ADDENDUM NO. 1

DEERFIELD
Federal Aid Project No. BFL(BR-OFF)-0032(052)X
Bridge Replacement, D-06-001,
Upper Road Over Deerfield River

Transmitting revisions to the Contract Documents as follows:

Revised Plan Sheets 47, 49, 50, 51, 52, 61 & 63 of 92.

STAGED CONSTRUCTION SUBSTRUCTURE 2 OF 2

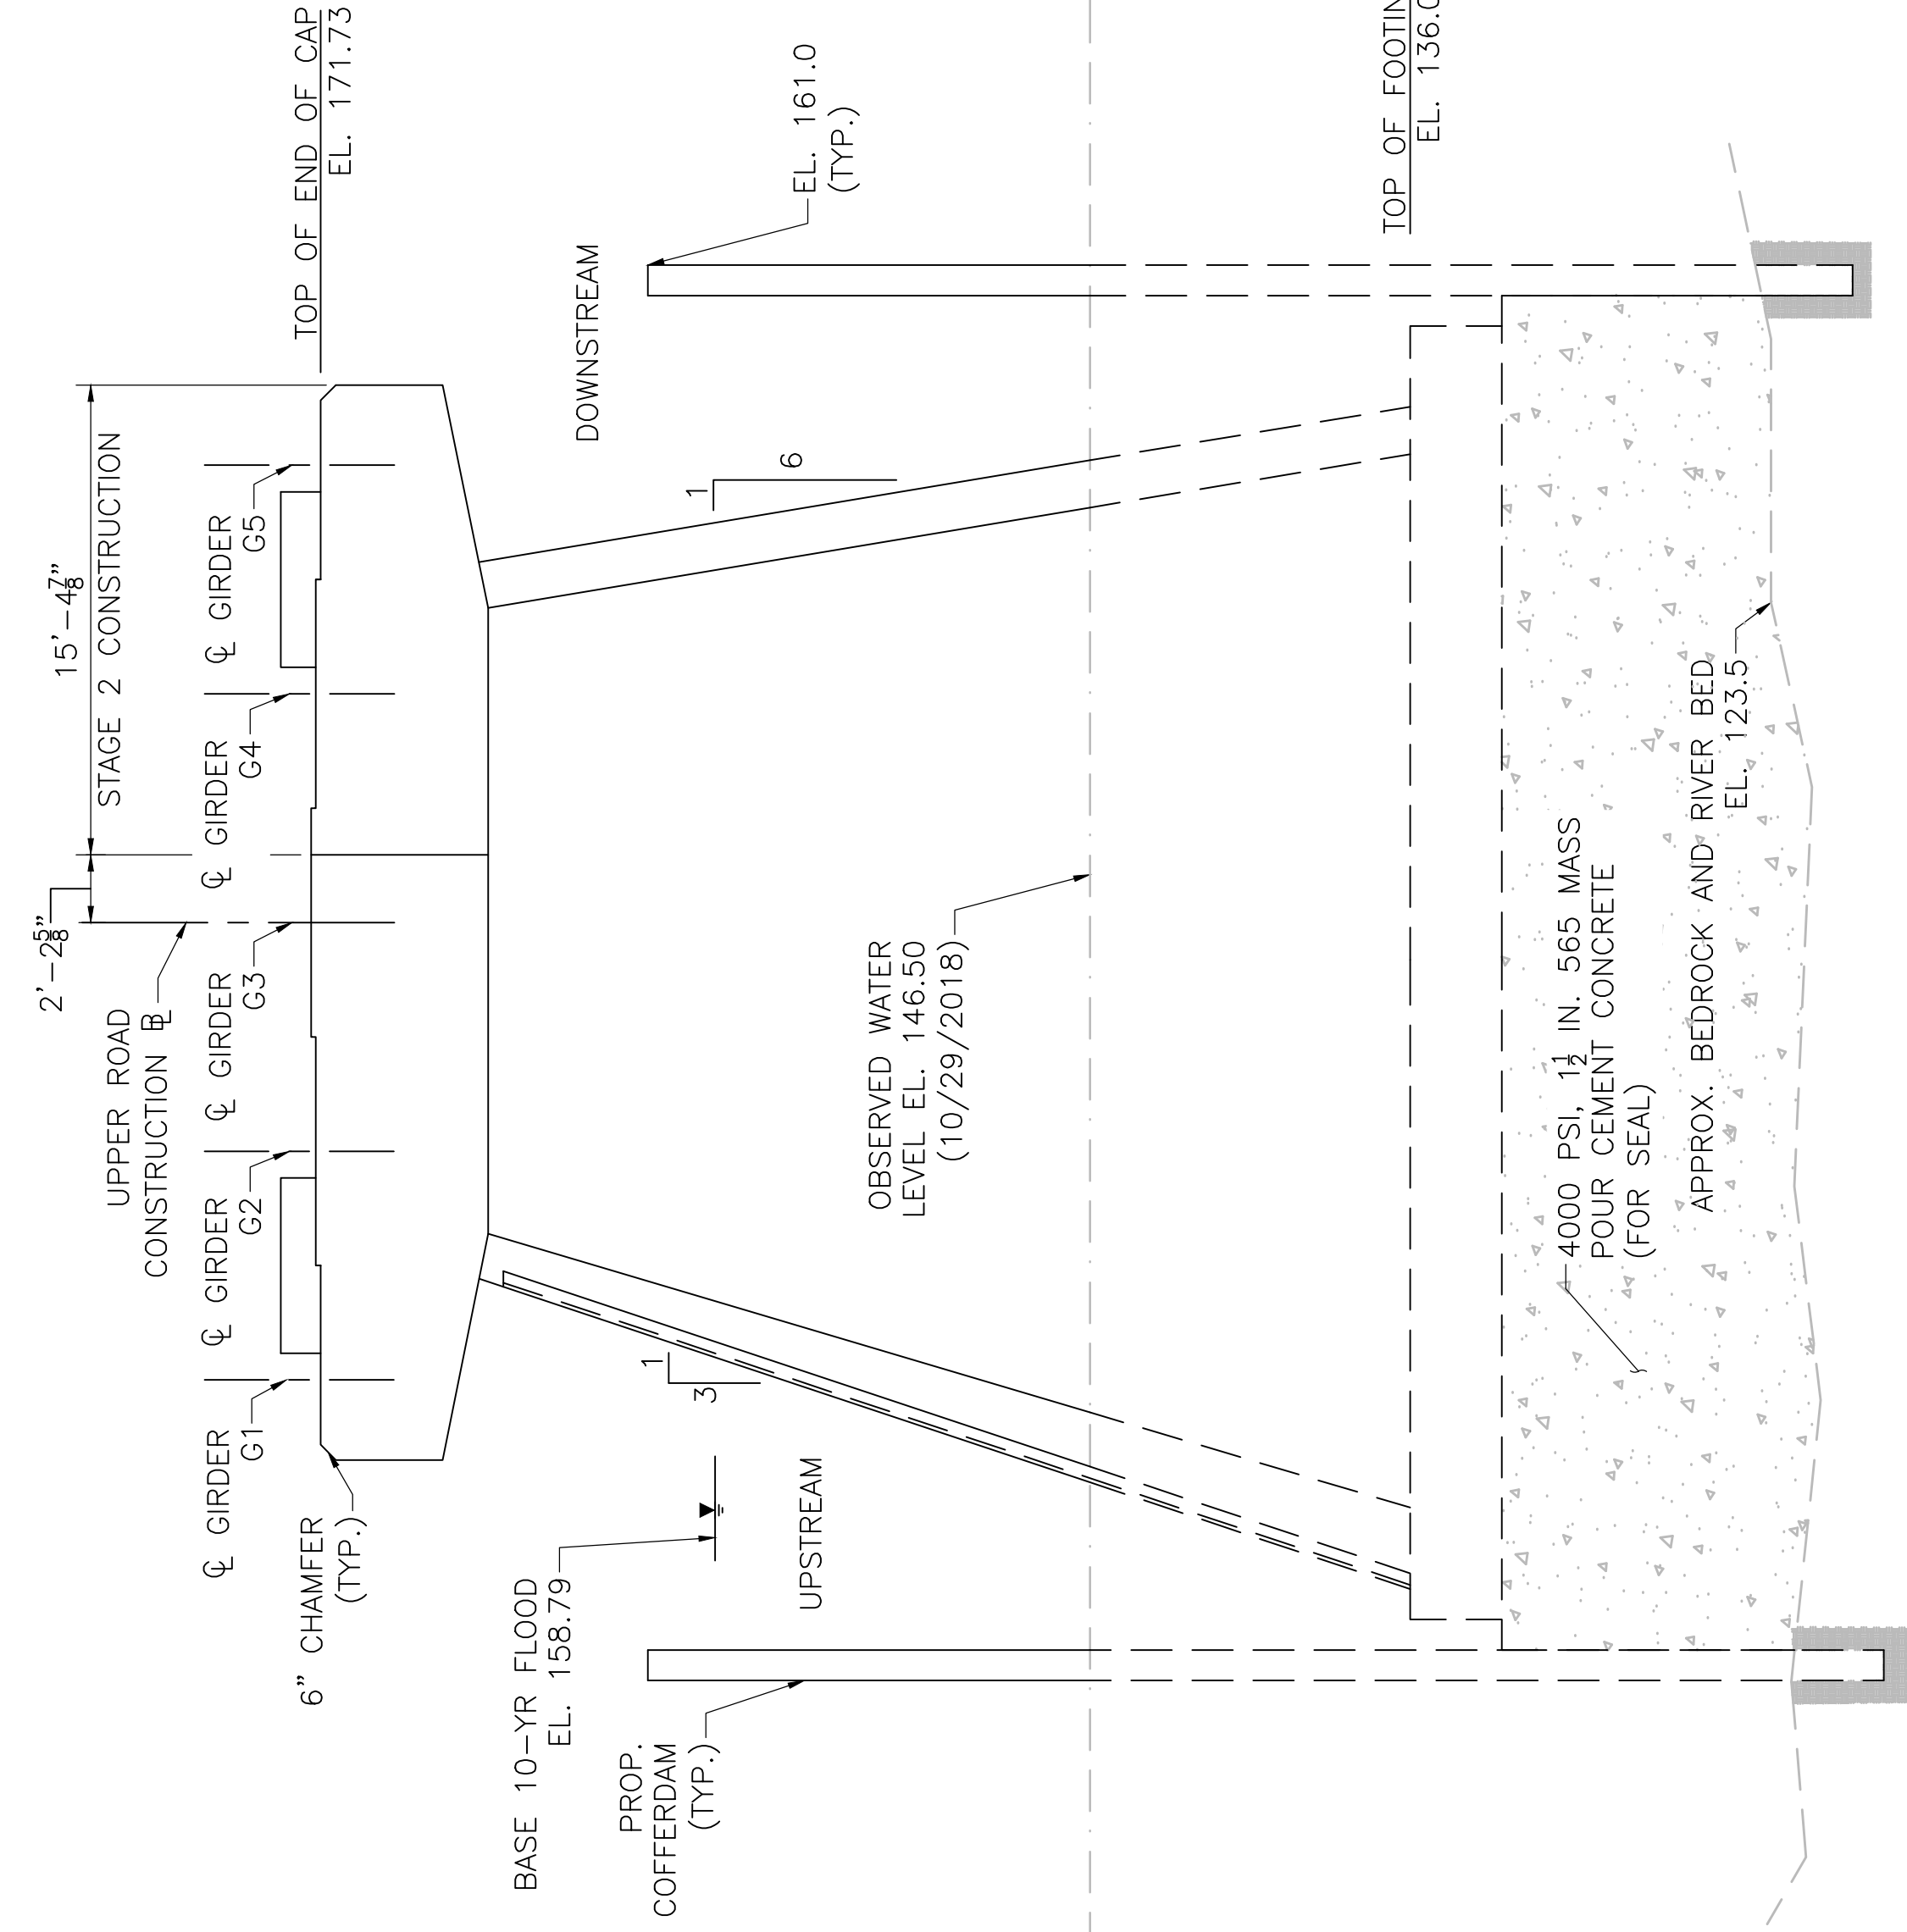
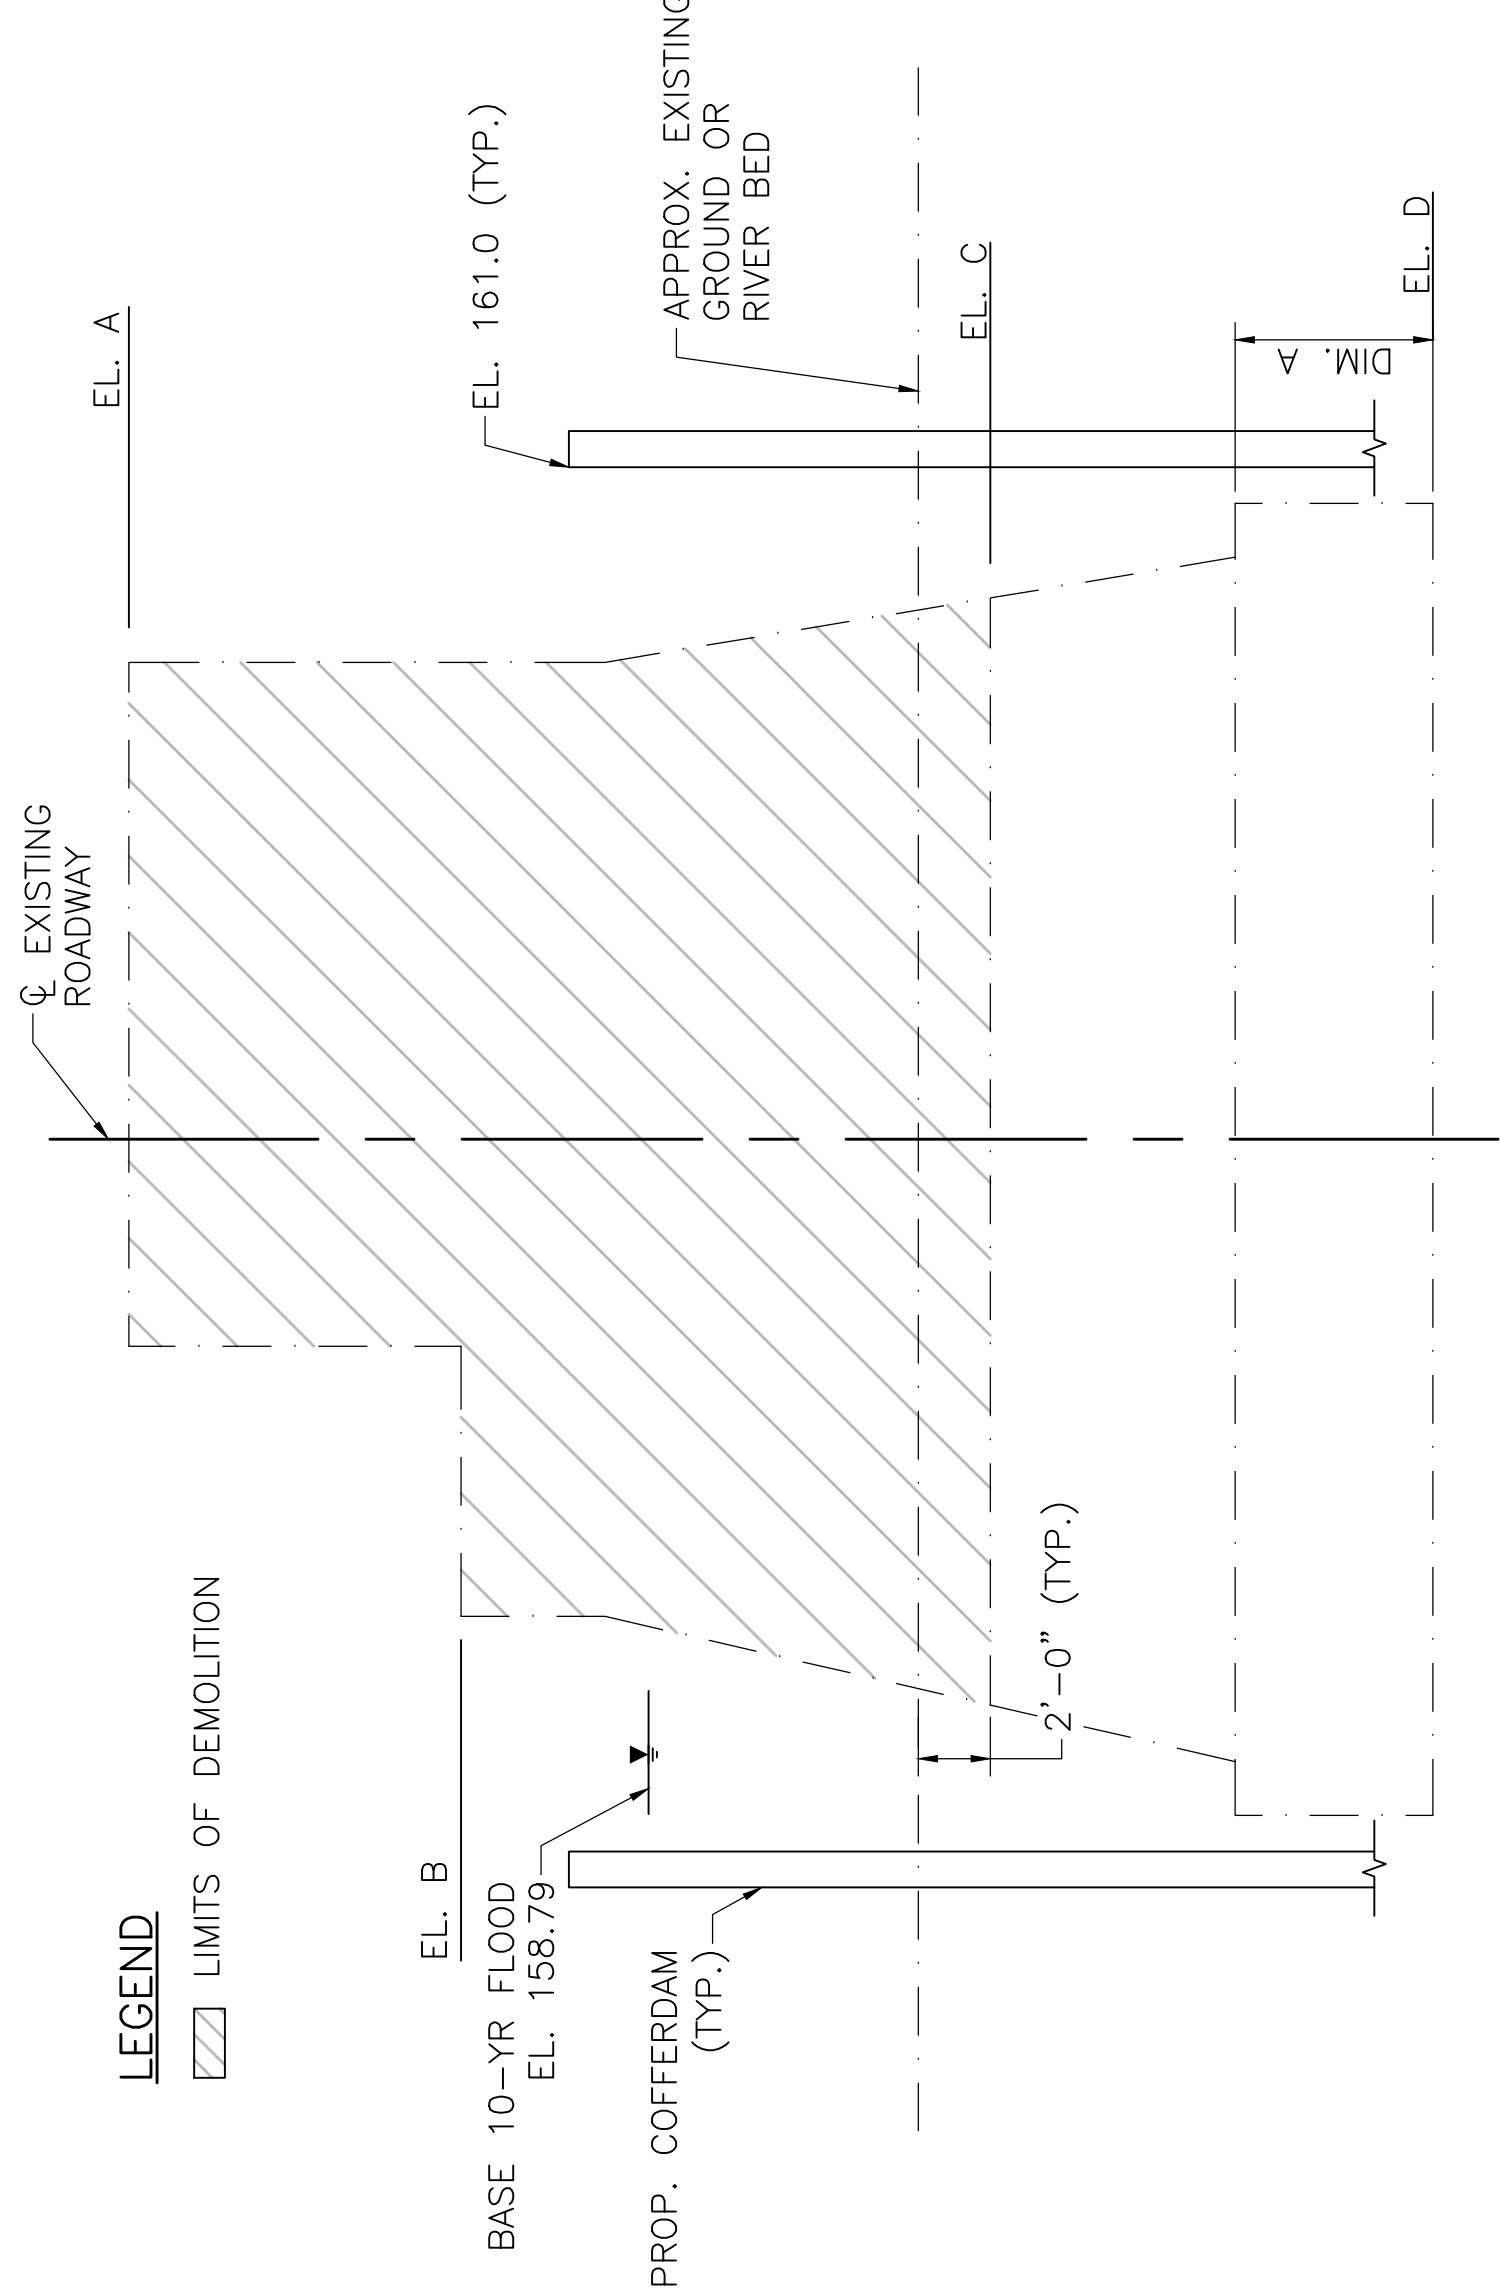
Can Pier 1 be installed and built with construction joints in the footing and stem for the phased construction approach, like what is shown for construction joints in the south abutment?

For pile locations requiring multiple splices due to headroom limitations, please confirm the required pile driving criteria, including any restrictions on driving spliced piles, maximum allowable hammer energy, splice inspection requirements, and any special procedures necessary to achieve the specified pile capacity.

See revised Plan Sheets 47 of 92 (11 of 41), 49 of 92 (13 of 41), 50 of 92 (14 of 41), 52 of 92 (16 of 41), 61 of 92 (25 of 41), and 63 of 92 (27 of 41) issued via this addendum.

- 2A. INSTALL THE REMAINING PROPOSED DRIVEN H-PILES AT THE SOUTH ABUTMENT AND AT PIER 1.
- 2B. CONSTRUCT THE STAGE 2 LIMITS OF THE PROPOSED ABUTMENTS, PIER 1, AND WINGWALLS.

June 26, 2026	STAGE 1 LIMIT ALTERED
May 30, 2026	ISSUED FOR CONSTRUCTION
DATE	DESCRIPTION
THIS SHEET IS APPROVED FOR CONSTRUCTION BY MASSDOT AUTHORIZED SIGNATORY: STATE BRIDGE ENGINEER	
USE ONLY PRINTS OF LATEST DATE
